FINAL DRAINAGE PLAN

LORSON RANCH EAST FILING NO. 1

MARCH 1, 2018

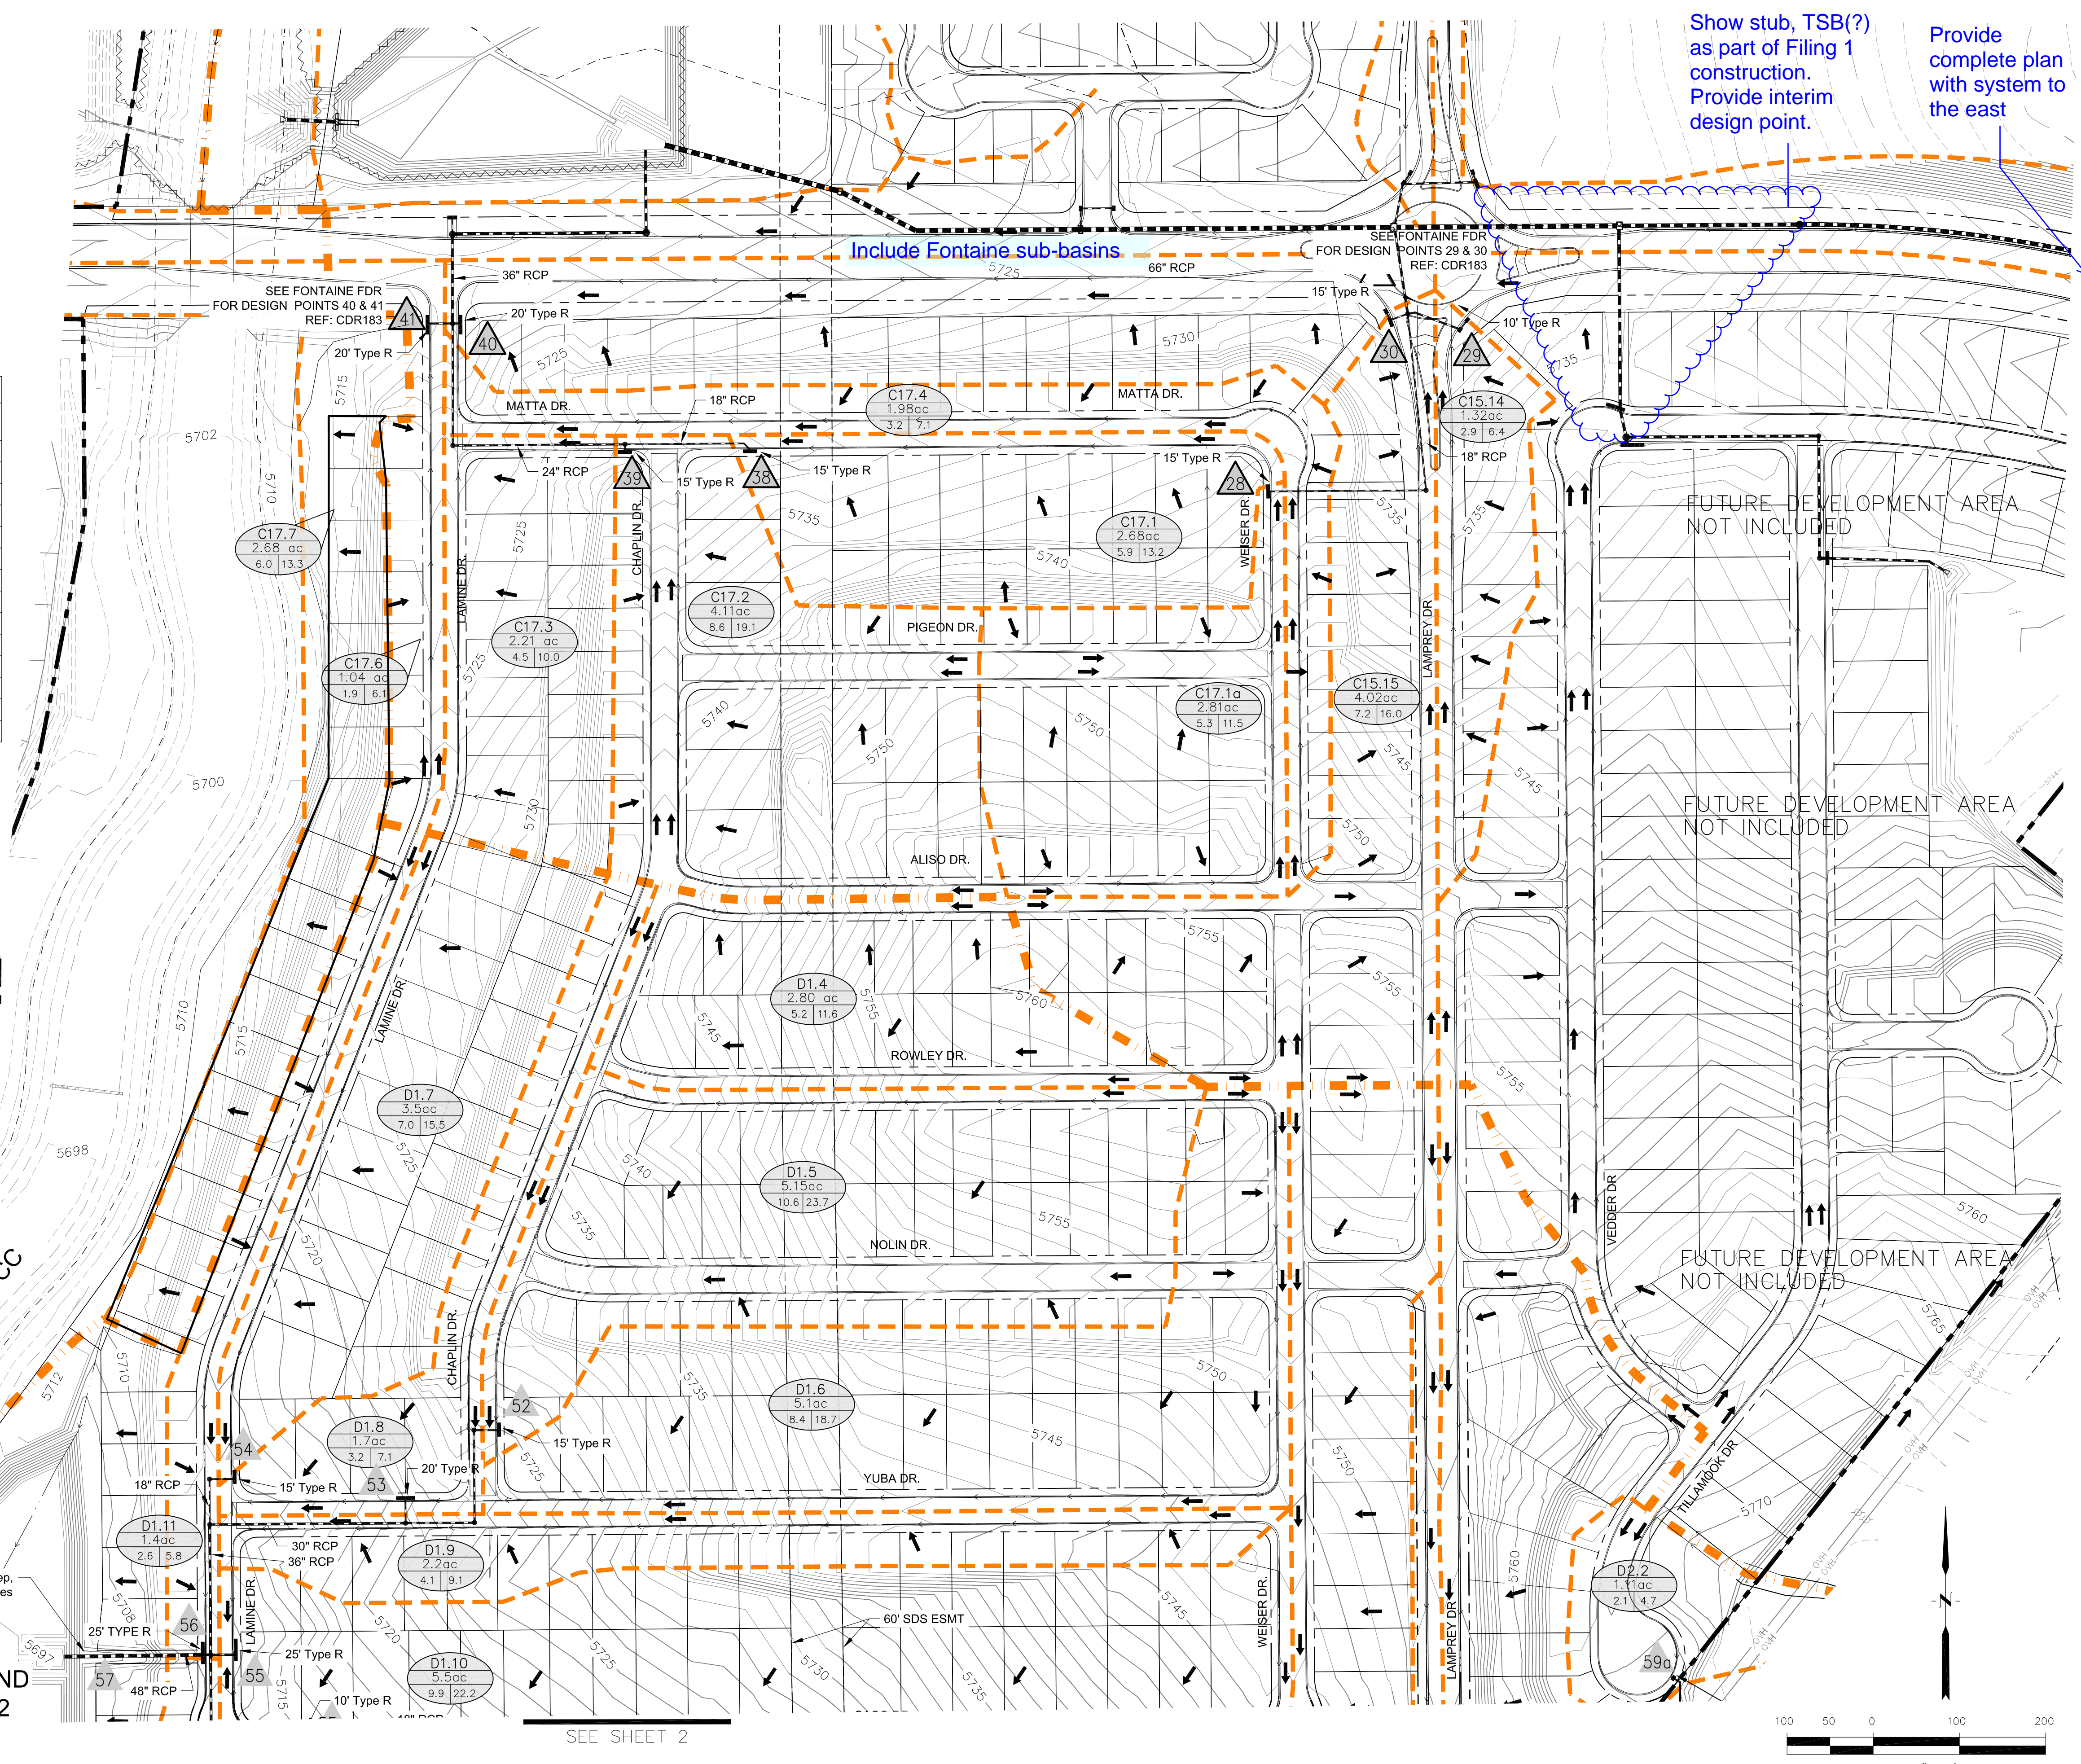
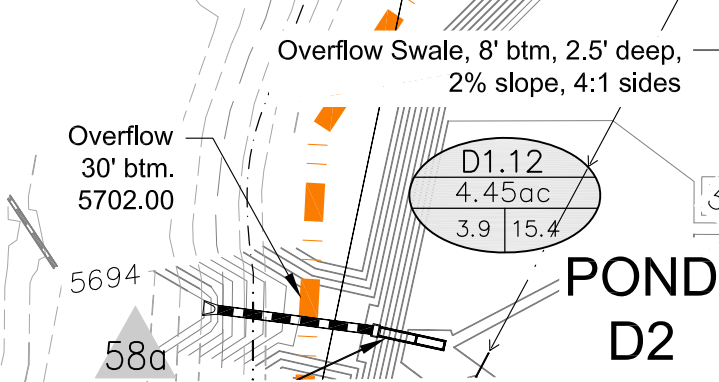
Show stub, TSB(?) as part of Filing 1 construction. Provide interim design point.

Provide complete plan with system to the east

DEVELOPED CONDITIONS
LORSON RANCH EAST FILING NO. 1

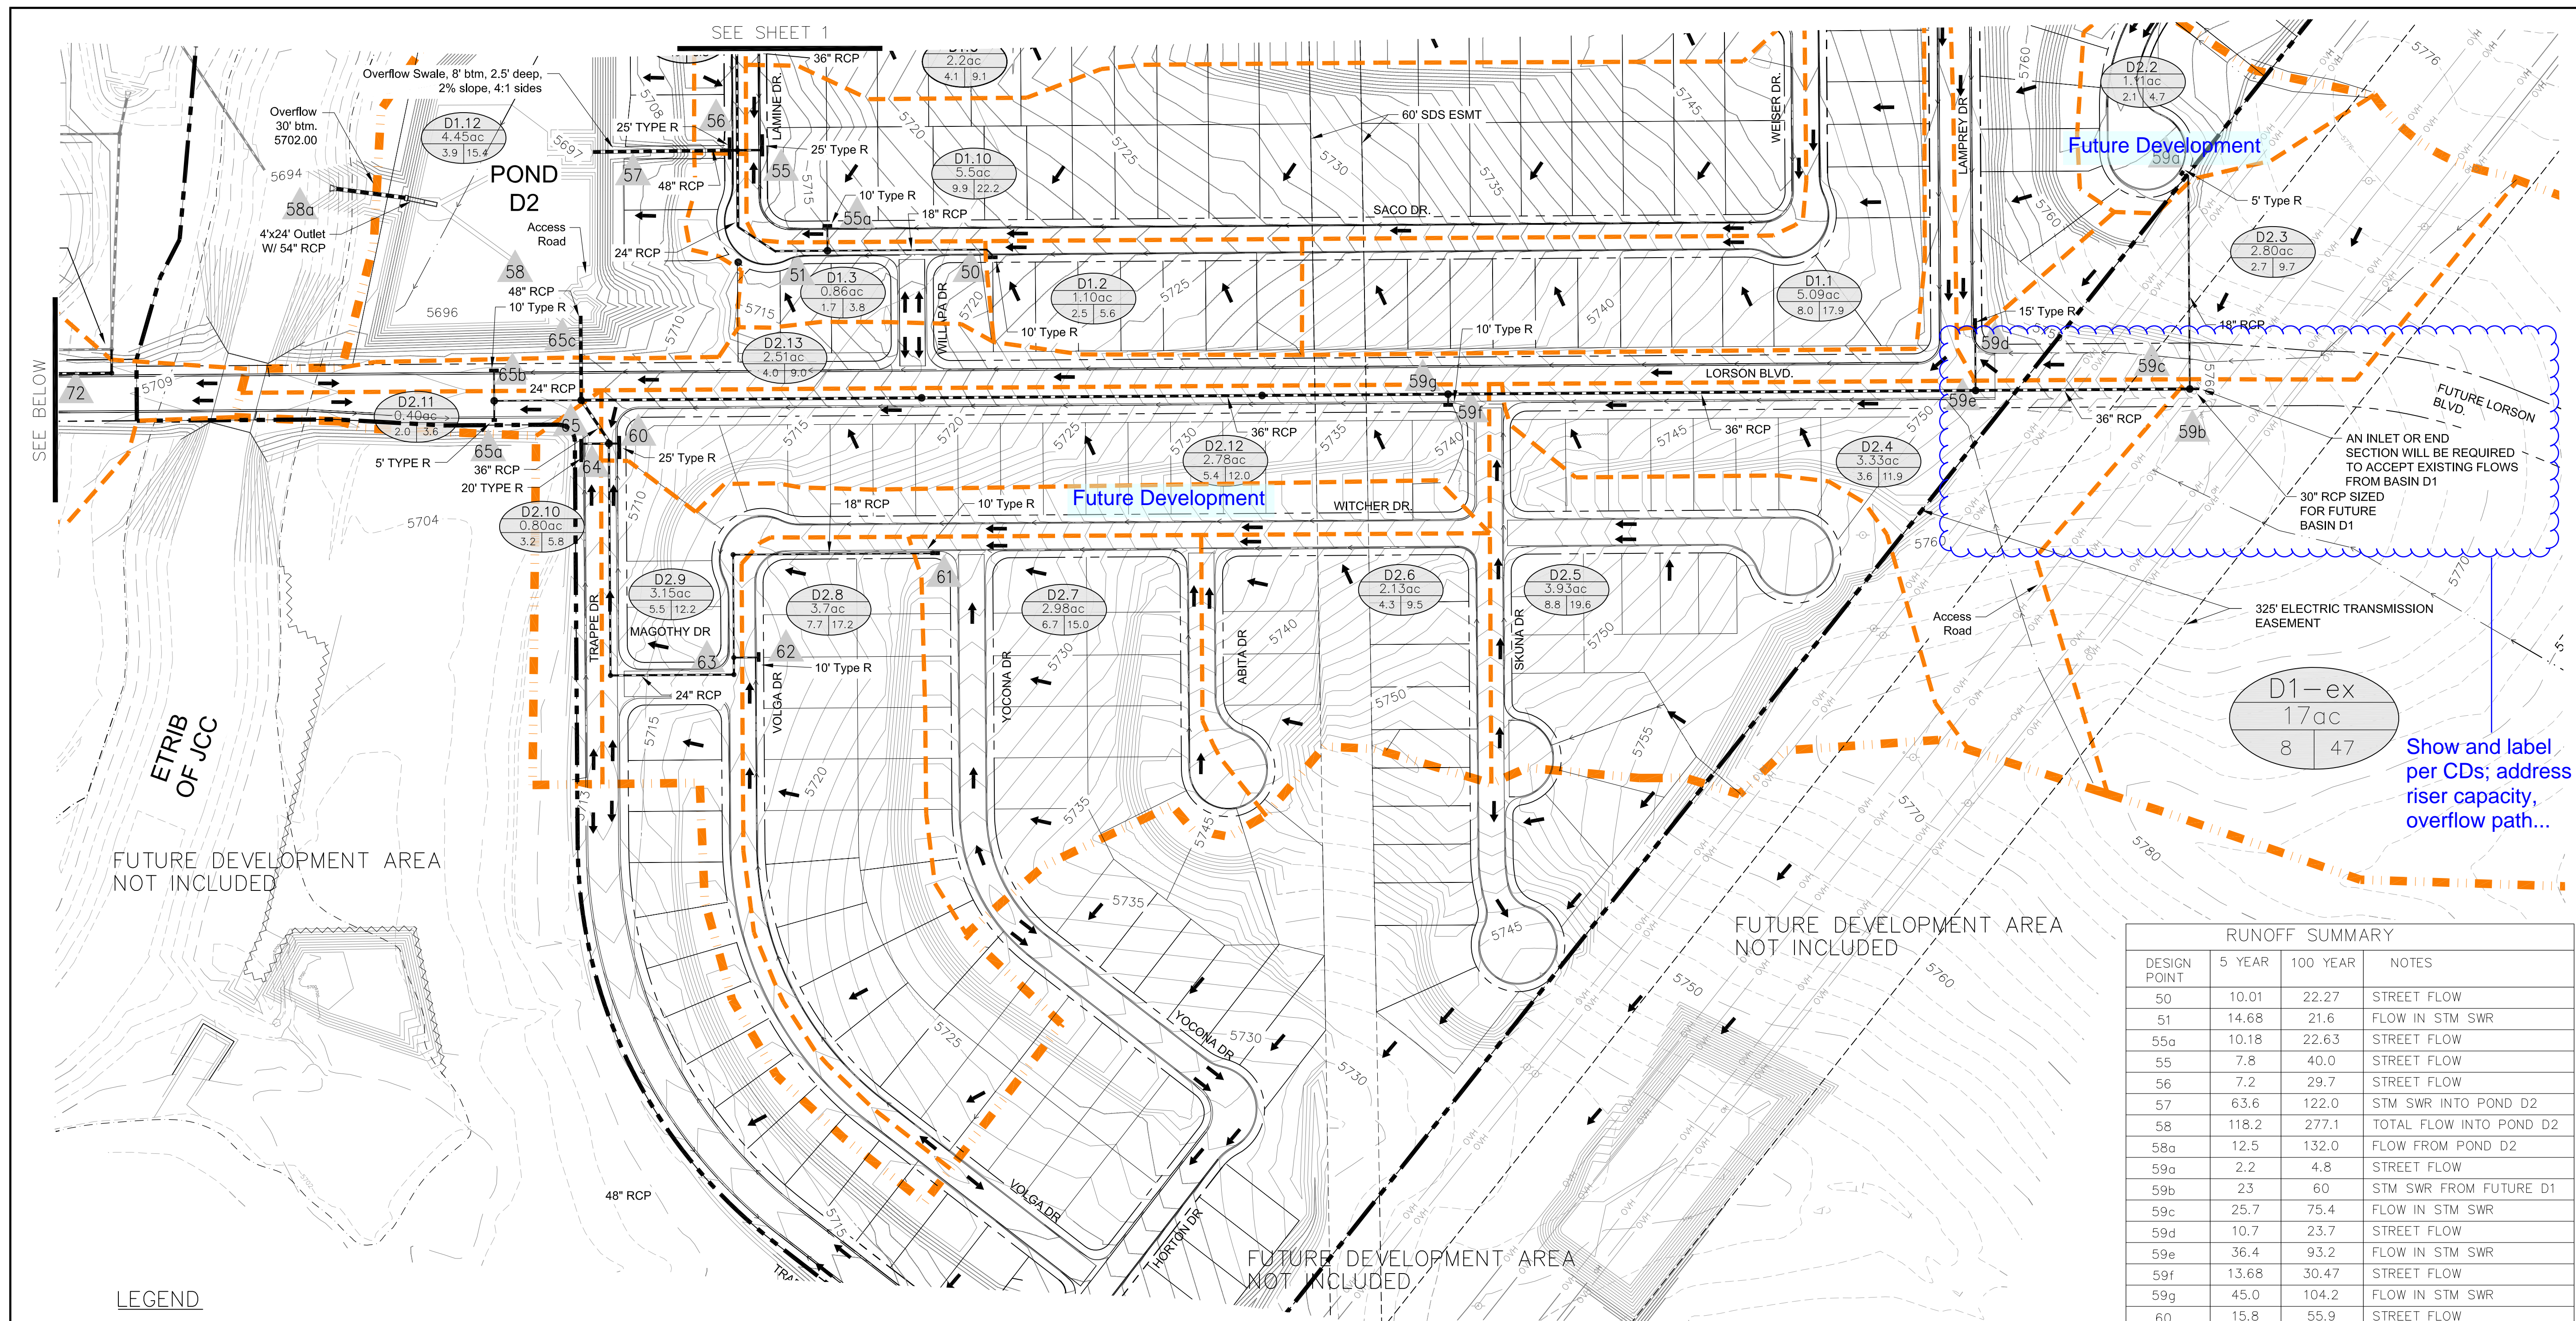
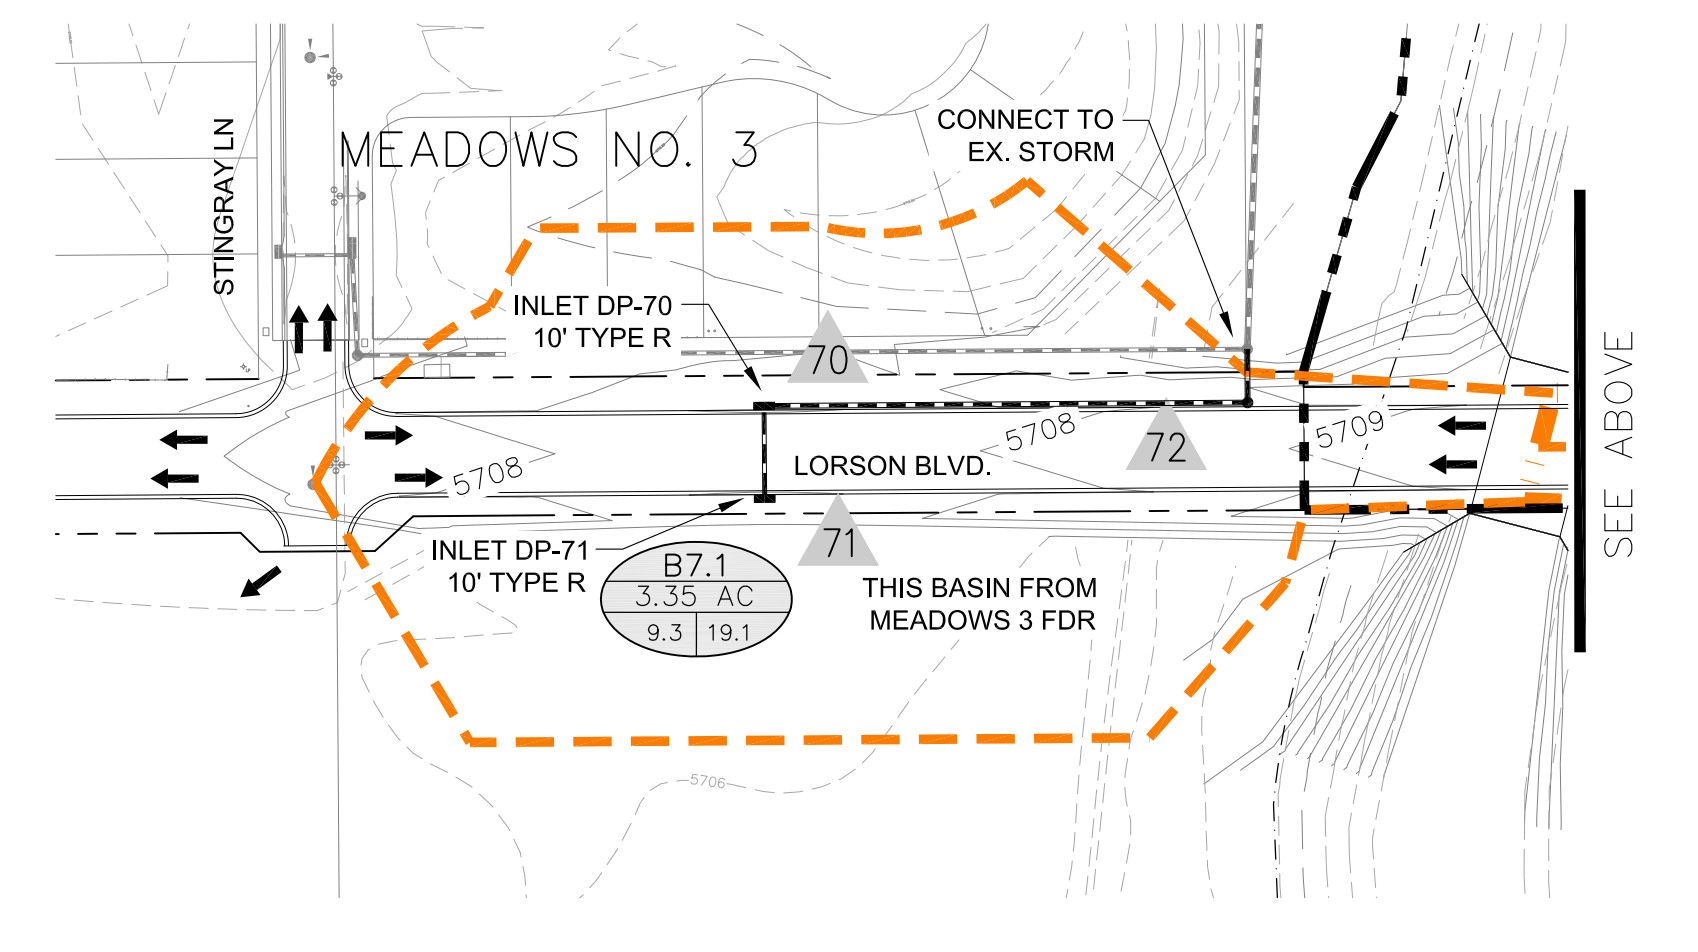
Show and label per CD's; address riser capacity, overflow path...
